**ASA Mechanical System Code Committee -  
Summary Report on May 2021 UMC and UPC Committee Hearings**

**UMC<sup>®</sup> TECHNICAL  
COMMITTEE MEETING  
MONOGRAPH**

VIRTUAL MEETING | **MAY 17 - 21, 2021**

**FIGURE 509.7.3.4(1)<sup>1, 2, 3</sup>  
EXTENT OF PROTECTION NECESSARY TO REDUCE CLEARANCES FROM GAS APPLIANCE OR VENT CONNECTORS  
[NFPA 54: FIGURE ~~10.3.2.3(a)~~ 10.3.3.3(a)]**

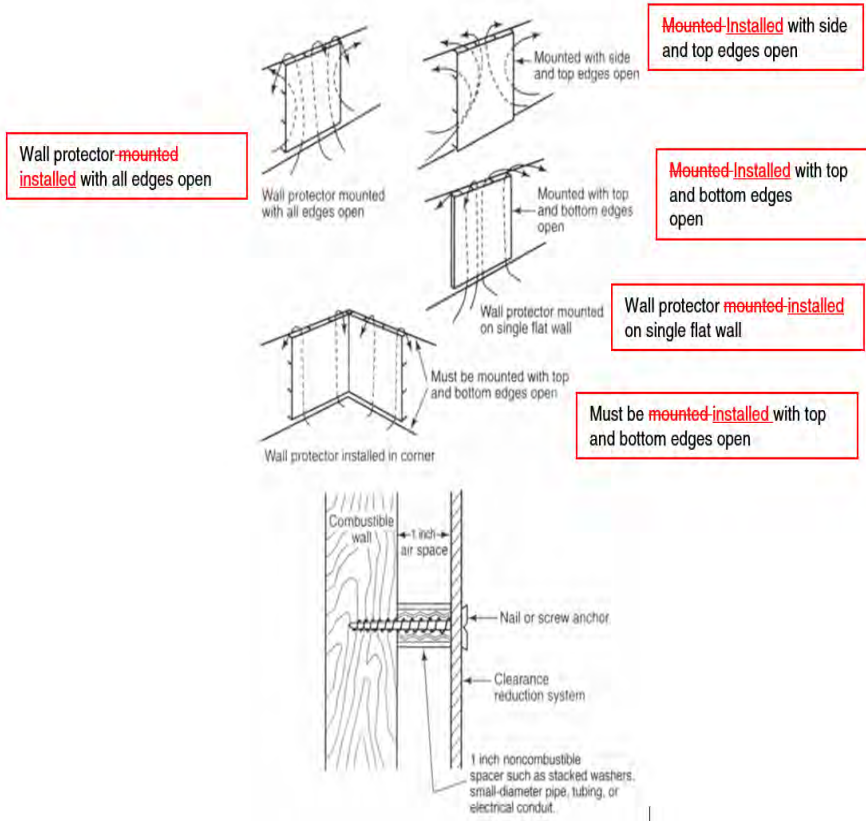
**SUBSTANTIATION:**

The above sections have been revised to correlate with NFPA 54-2021 (latest version) in accordance with IAPMO's Regulations Governing Committee Projects (Extract Guidelines).

**FIGURE 509.8-509.8.1**  
**EXIT TERMINALS OF MECHANICAL DRAFT AND DIRECT-VENT VENTING SYSTEMS**  
**[NFPA 54: FIGURE A.12.912.9.1]**

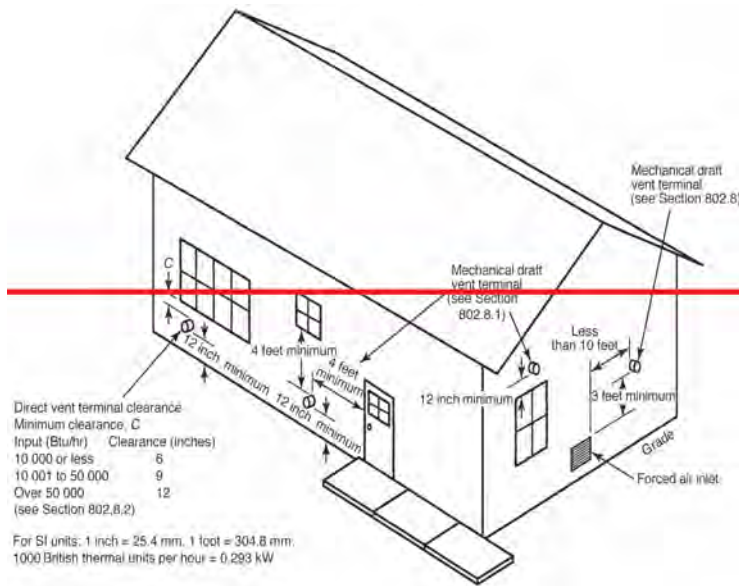
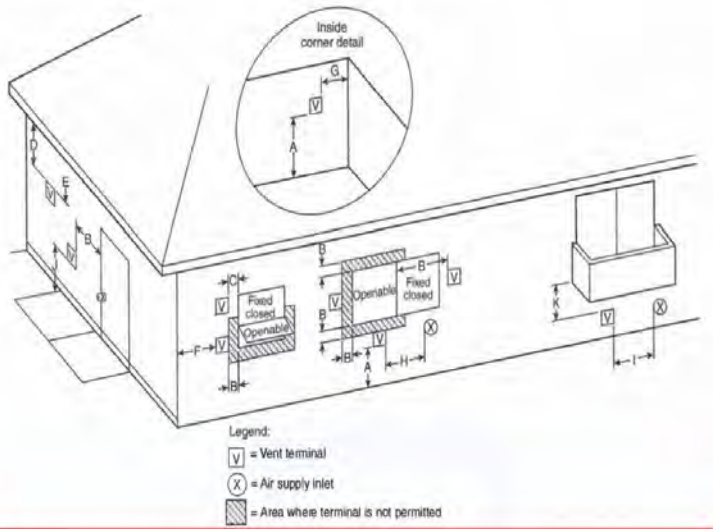
**509.8.1 Clearance for Through-the-Wall Vent Termination.** The clearances for through-the-wall direct vent and non-direct vent terminals shall be in accordance with Table 509.8.2 509.8.1 and Figure 509.8.1. The bottom of the vent terminal and the air intake shall be located not less than 12 inches (305 mm) above finished ground level.

**FIGURE N 104.1**  
**WATER TEMPERATURE RANGES AND LEGIONELLA GROWTH POTENTIAL\***

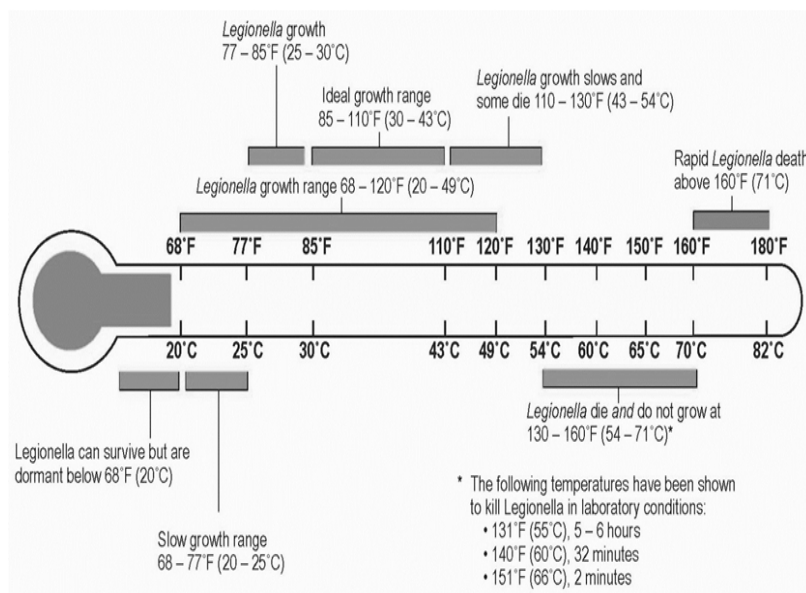
Included in the recommendations are a new Figure N 104.1 that is a specifically scaled for Legionella growth potential. Figure N 104.2 (formerly Figure N 104.1) remains mostly unchanged, except that the Legionella growth potential temperature ranges have been relocated into a separate figure, Figure N 104.1. This update simplifies the temperature ranges for Legionella growth potential and scald potential and adds clarity for the end user on the use of the figures and assists when acquiring the important information needed. The updates also include a distinction between chemical and non-chemical disinfection and treatment criteria, remediation guidelines for domestic water, and an emergency response plan.
